# ADDENDUM NO. 1

**June 13, 2024**

## **PORTER COUNTY HIGHWAY DEPARTMENT – CENTRAL FACILITY**

This Addendum consists of Page ADD 1-1 through ADD 1-4, revised Specification Section 00 20 00 – Information Available to Bidders, attached Addendum No. 1 from A & Z Engineering, consisting of 1 page and 8 drawings, and attached Addendum No. 1 from MartinRiley, consisting of 4 pages, Specification Sections 00 01 10 - Table of Contents, 07 42 13 – Metal Wall Panels, 07 71 00 - Roof Specialties, 10 28 00 - Toilet, Bath, and Laundry Accessories, 11 11 19 - Vehicle Lubrication Equipment, 23 31 00 - HVAC Ducts and Castings, 41 22 00 - Hoists and Cranes, and 13 Drawings.

# C110

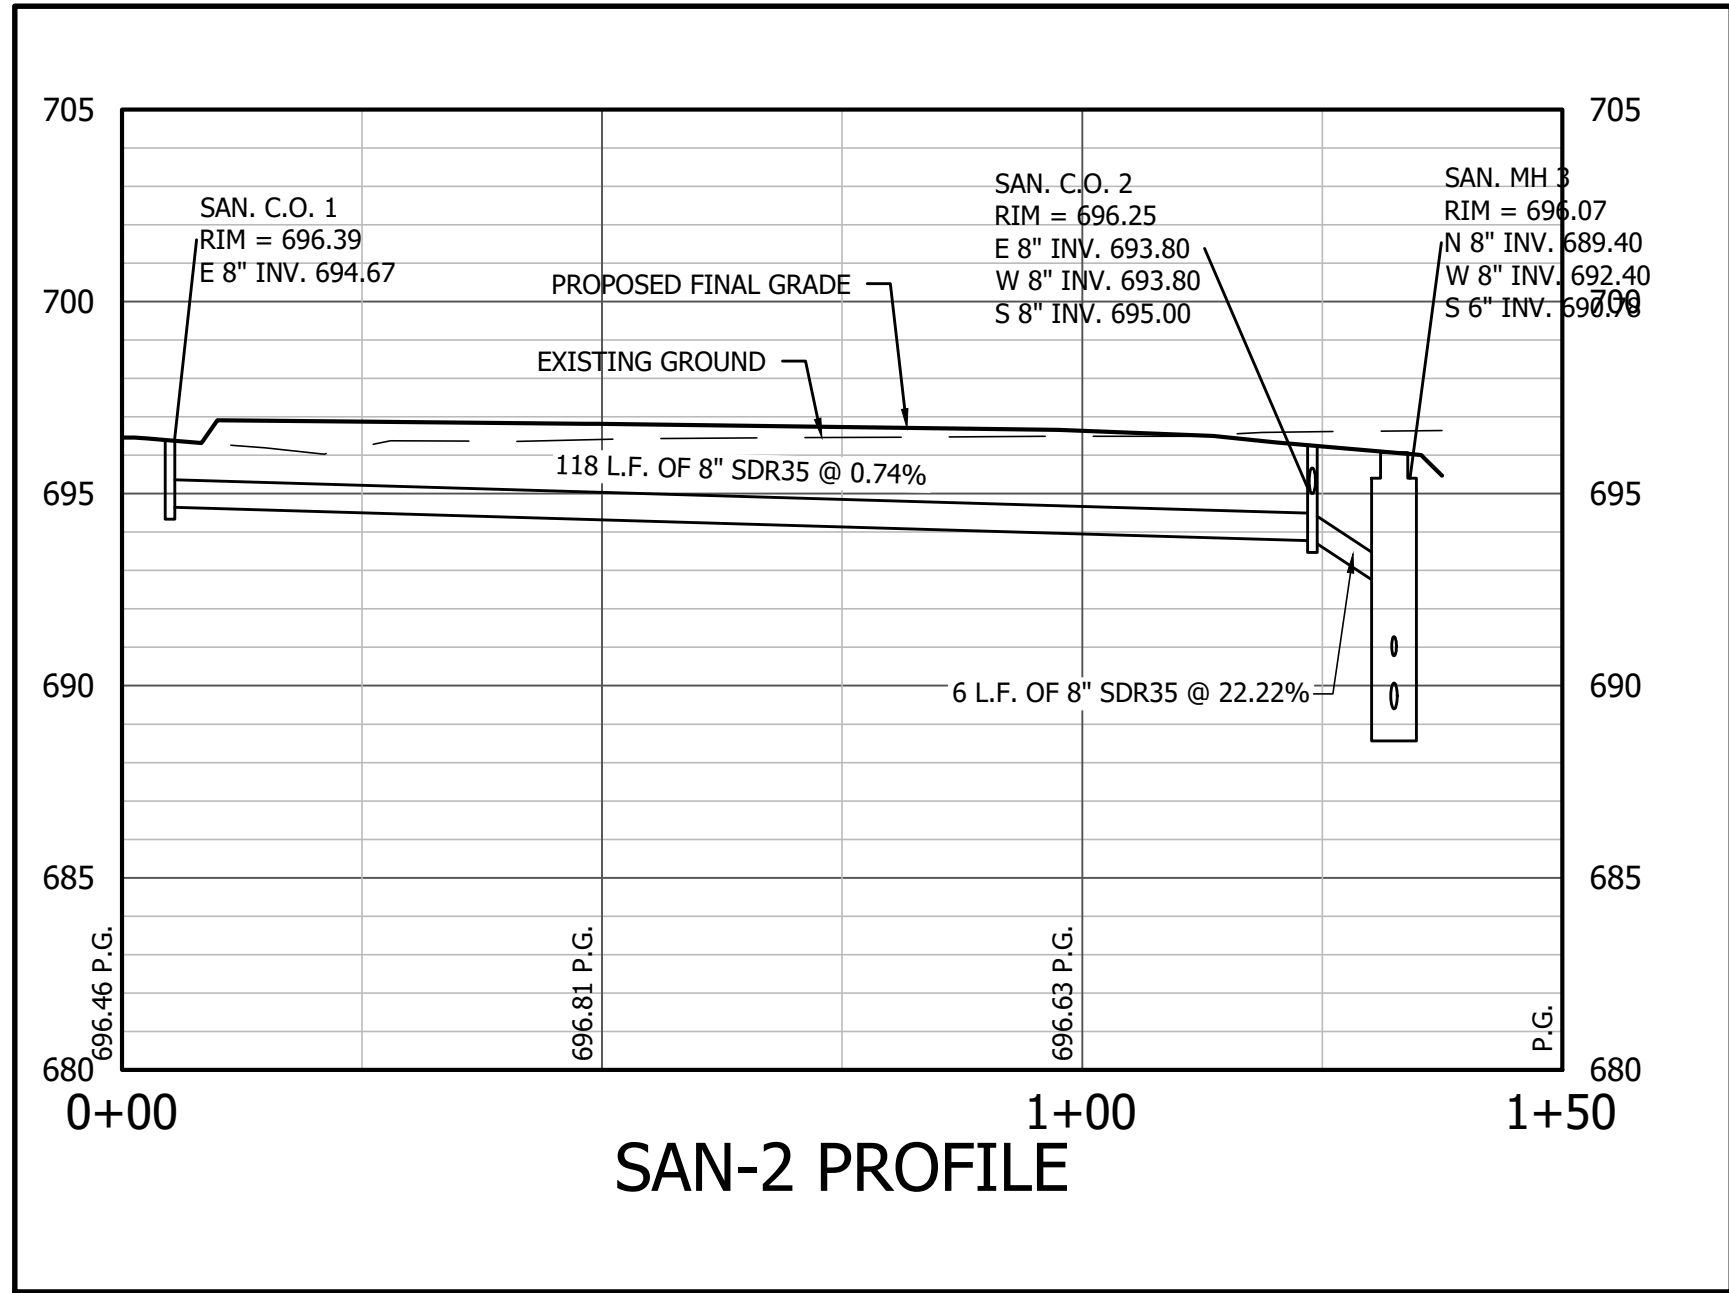
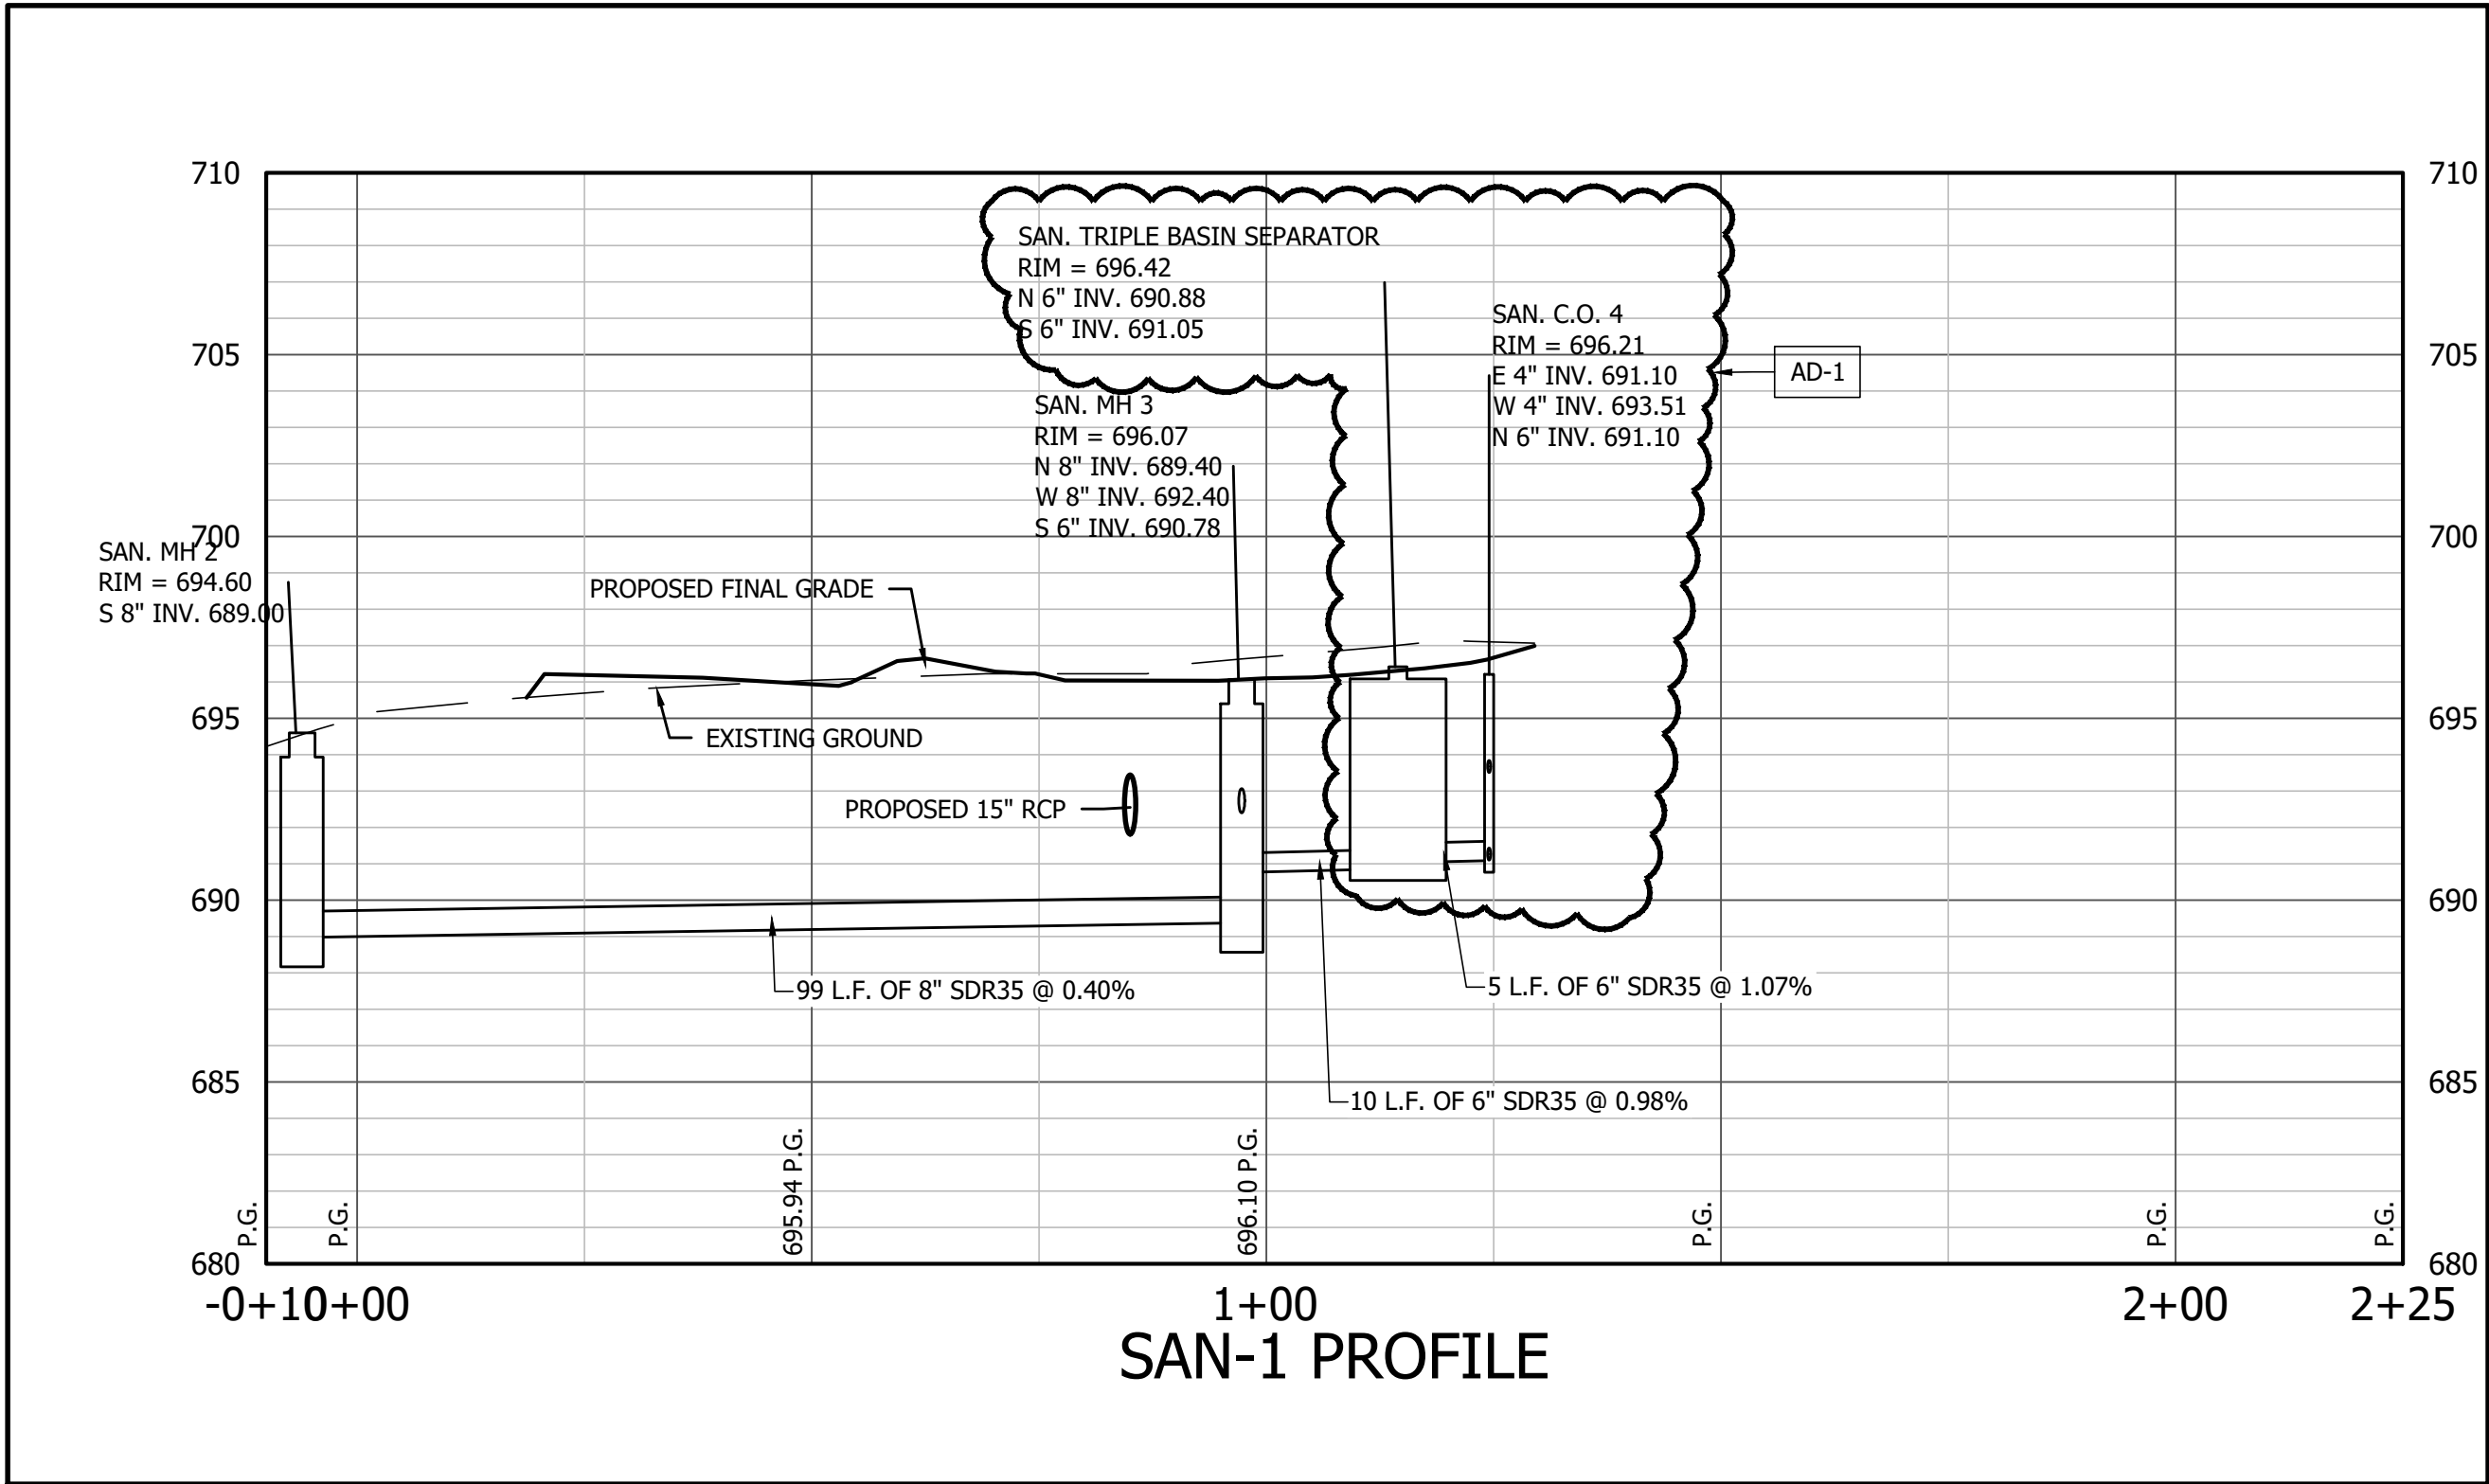
4. Sheet C110 – Sanitary Sewer Utility Plan
  - a. Changed callout for Sanitary Interceptor to Sanitary Triple Basin Separator.
  - b. Revised invert elevations for the following structures:

- Sanitary Manhole 3
    - Sanitary Triple Basin Separator
    - Sanitary Cleanouts 4, 5, 6, 7, 8 & 9
  - c. Revised slopes of sanitary sewer pipes (SDR-35) between the following structures:

- Sanitary Cleanouts 5 & 6
    - Sanitary Cleanouts 6 & 7
    - Sanitary Cleanouts 8 & 9
5. Sheet C112 – Sanitary Sewer Profiles
  - a. SAN – 1 Profile
